We thank the reviewers for their comments. Below are our responses in blue.

Response to Reviewer 1

The comments of “egosphere-2023-1807 Water Vapor Measurements inside clouds and storms using a Differential Absorption Radar” by Millán et al.

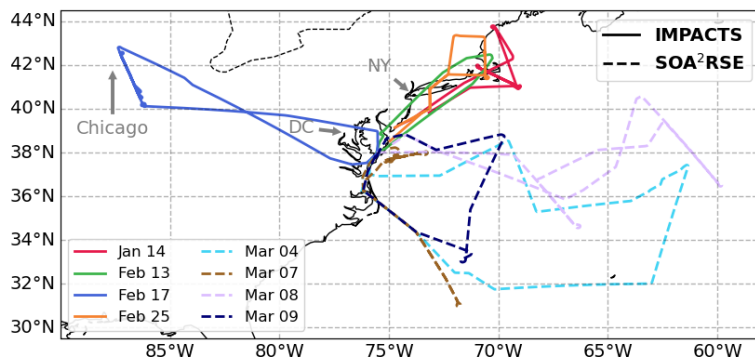
- L 281: I understand that ERA5 gives an hourly snapshot with a resolution of 31km; airborne data is averaged to 10km and 1min. How do the authors account for differences due to these temporal and spatial scales of the VIPR-ERA5 comparison? By interpolating the model to the airborne data, the model output gets oversampled. In order to avoid such spatial and vertical oversampling of the model pixels, the comparison should rather be performed on model

resolution. This would additionally allow to quantify the model's sub-pixel variability. How strongly does the performance of VIPR-ERA5 depend on this variability?

All comparisons are now made on the model resolution.

We deleted: To ease comparison, the ERA5 humidity fields were interpolated to the VIPR measurement times and locations. And added: To ease comparison, we identified the nearest ERA5 humidity field spatially and temporally.

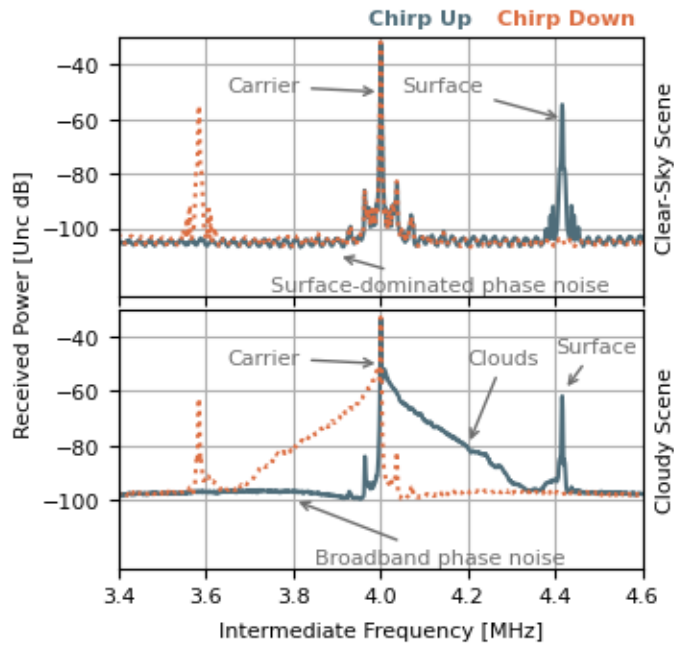
- drop Fig 2: readily available in literature (eg Roy et al 2018, Fig 3). While we agree that this figure is available elsewhere, we believe is important to have it so the reader understand the chirp up/chirp down difference. Many readers of this paper will likely not be experts in FM radar techniques which are essential to understand Fig 3.

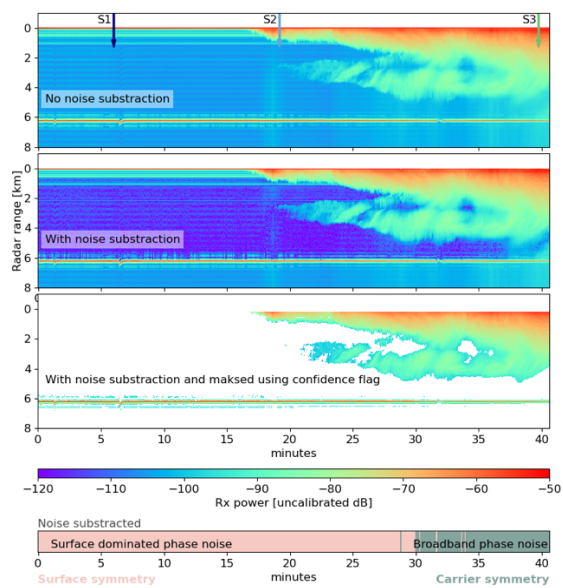
- Fig 3: add bottom row to upper panel to reduce to two panels Again, thank you for this suggestion, Figure 3 was changed as requested.

In the caption we added: The labels highlight features in the chirp up power spectrum, while mirror features can be found in the chirp down power spectrum.

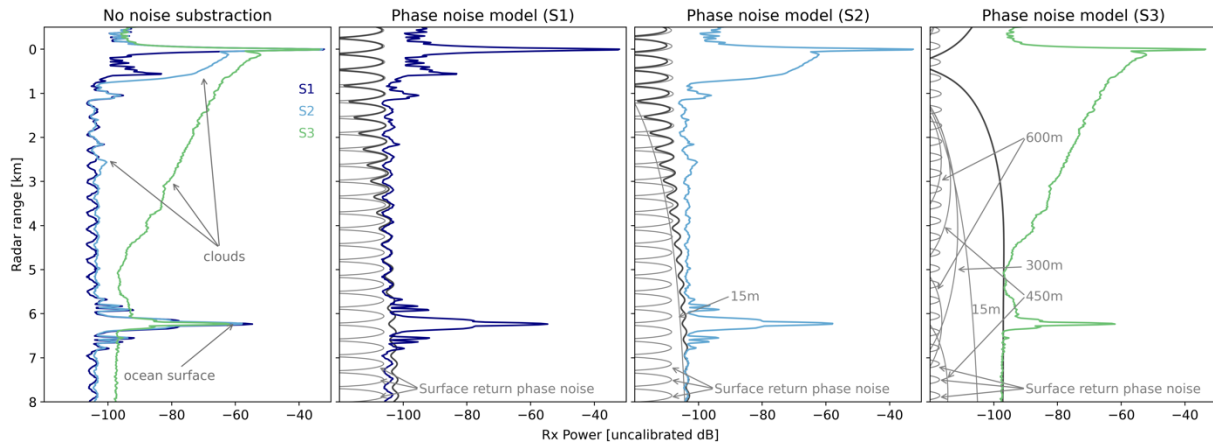
- reshuffle Figure 4 and 5, e.g. by adding the bottom panel of Fig 5 below Fig 4; and combining most right panel Fig 4 with three panels Fig 5.

The figures were reshuffled as requested:

With the caption now reading: Uncalibrated VIPR 167.12 GHz reflectivities measured during the first ~40 minutes of the January 14 flight with no noise subtraction (top), with noise subtraction (middle), and with noise subtraction and confidence flag (bottom). The noise subtraction is indicated by the pink/green bar (for phase noise and thermal noise, respectively).

With the caption now reading: (left) Radar reflectivities at the three slices indicated in Figure 4, depicting scenarios with clear sky (S1, navy line, featuring a bright reflection around 6.5 km), a partly cloudy scene (S2, light blue), and a cloudy scene (S3, green). (right) Phase noise model simulations for each of these slices. The integrated phase noise model is depicted in dark gray, while phase noise model examples at different ranges are shown in light gray.

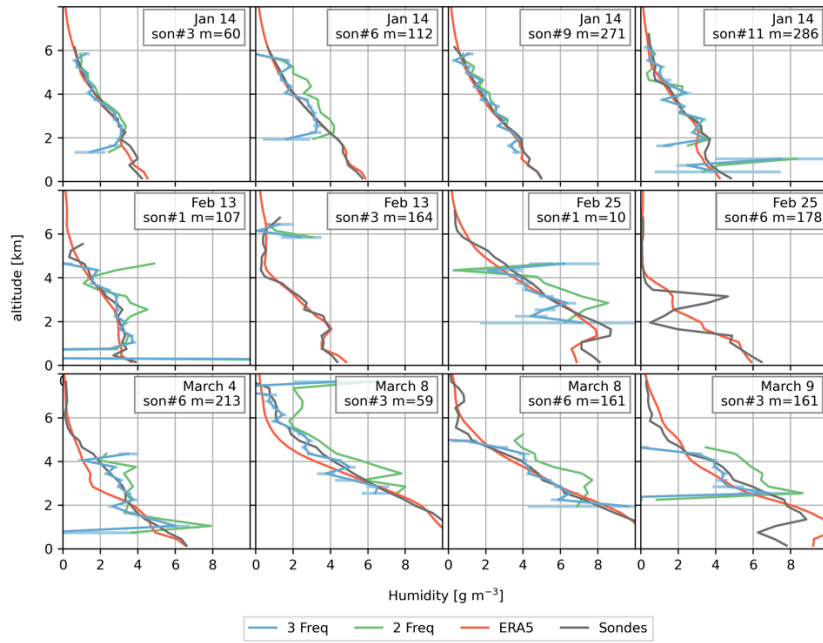
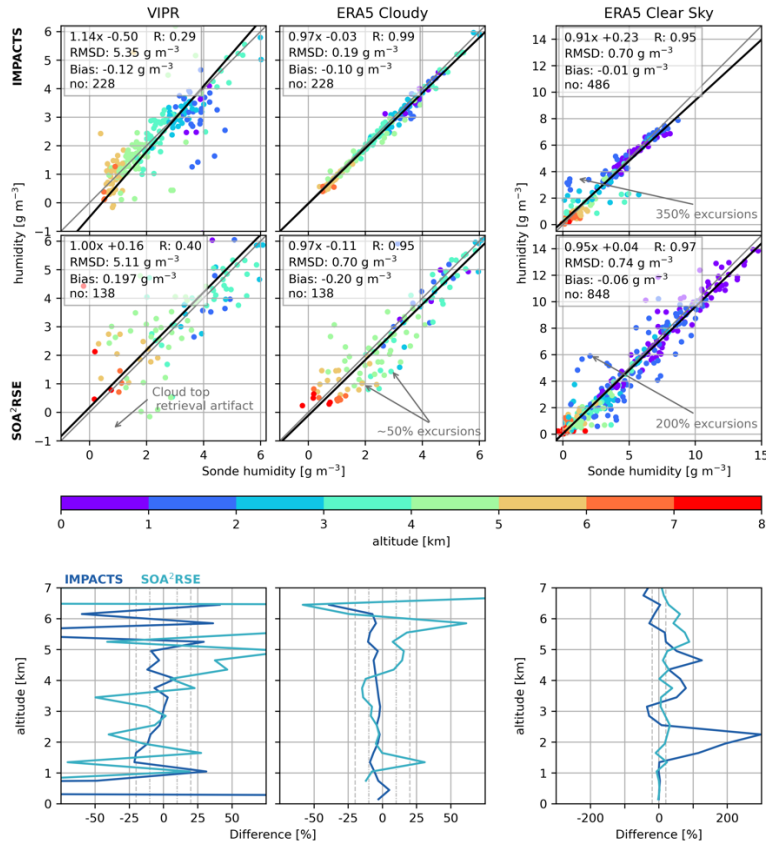
- LL 358: The authors should motivate the chosen 10 minute averaging interval. How sensitive is the comparison to this interval? I think that the evaluation of the VIPR retrievals with respect to dropsondes should be analysed before the ERA5 assessment (see comment above) as retrieval evaluation.

Below are the corresponding figure 10 and 11 showing the comparisons averaging 2 minutes (i.e., one minute before and one minute after). As shown the results are similar but noisier especially for the SOA2RSE differences in the figure 11 equivalent (first panel, bottom row of the second figure below).

Note that these comparisons uses all the available points while the 10 minutes averages (shown in the paper) only uses bins with at least 150 VIPR water vapor estimates (less than half of the maximum number for the 10 minute window) to ensure a cloudy volume.

In the manuscript we added: The 10-minute average was chosen to reduce noise, especially when comparing it against the radiosondes dropped during SOA2RSE, where the clouds were scattered, in contrast to the continuous cloud cover during IMPACTS.

Figure 15: Normalized histogram of the humidity retrievals during the SOA²SE March 8th and March 9th flights using either DAR/VIPR or DIAL/HALO. The numbers in brackets represent the number of samples per instrument.

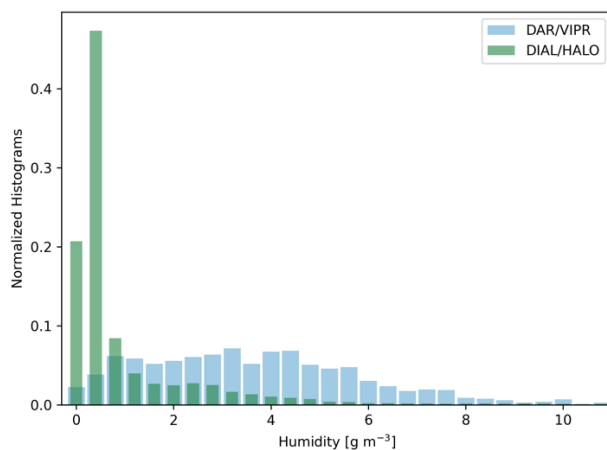
- Section 6 is very short and vague compared to Sec 4 and 5 while it is in my opinion one of the most novel findings of the paper. The authors should thoroughly quantify the synergistic benefits of the two instruments. The following questions could guide the analyses: How well do clear-sky pCWV agree between the two instruments? What happens at the edges from clear-sky to cloudy, when DIAL and DAR water vapor profiles follow one another temporally? How well do water vapor observations agree above cloud top (DIAL profile vs DAR pCWV)? I would suggest to add a Figure similar to Fig 13 to analyse the clear-sky pCWV.

A thorough quantification of the synergistic benefits of DIAR and DAR are outside the scope of this manuscript. That said, we added the following figure to further highlight the synergy of the two techniques.

To underscore the synergy of these techniques, Figure 15 displays the normalized histograms of the water vapor values retrieved by either DIAL/HALO or DAR/VIPR. As shown, DIAL/HALO displays a skewed right distribution with mode at 0.4 g m^{-3} (attributed to a majority of clear sky measurements), while DAR/VIPR exhibits a multimodal broad distribution with modes at 0.8 and 4.4 g m^{-3} . This synergy could ...

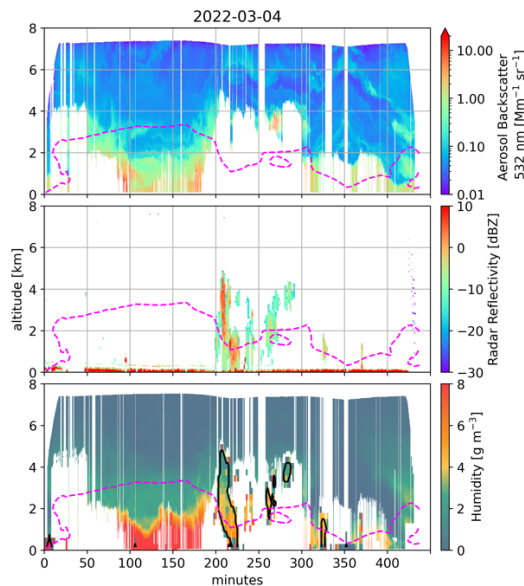
The authors should also comment on the performance of the synergy for the 03-04 and 03-07 flights. We added the figure below as an appendix figure.

In the manuscript we added: Similarly, Figure A1 displays the March 4th flight, note that there were no cloudy measurements on the March 7th flight.
